## 249 Transmission Lube Fitting & Hose Change

**Effective Date:** PTOs built on and after May 3, 2016

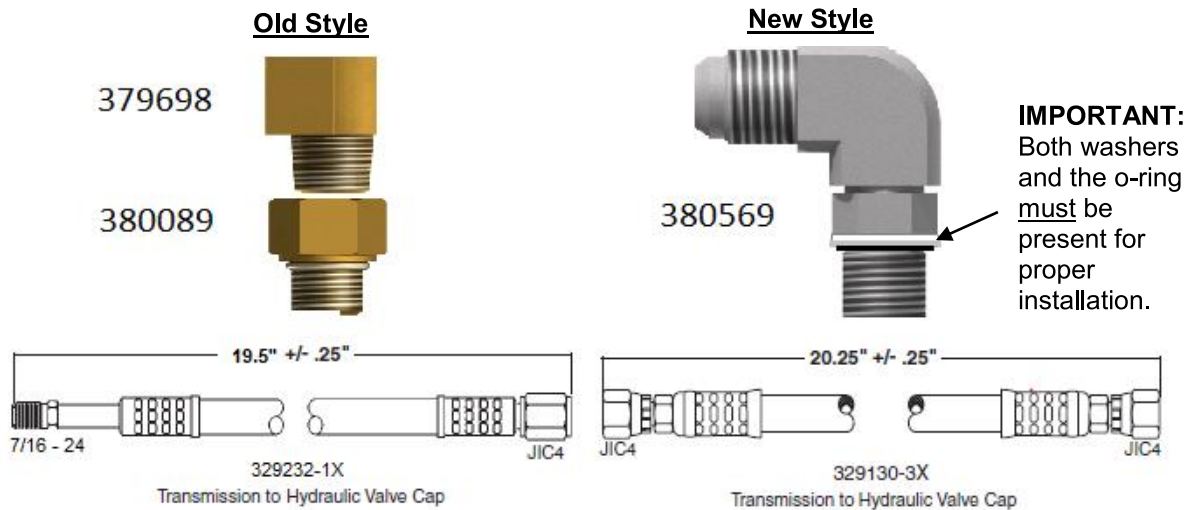
For the sake of simplicity, Chelsea has combined two fittings into one for the Shift Pressure/Lube Hose installation on the 249 for the FORD 6R140 TorqShift ® transmission.

Part number 380569 will now replace 380089 & 379698. The Pressure/Lube Hose Assembly has also changed.
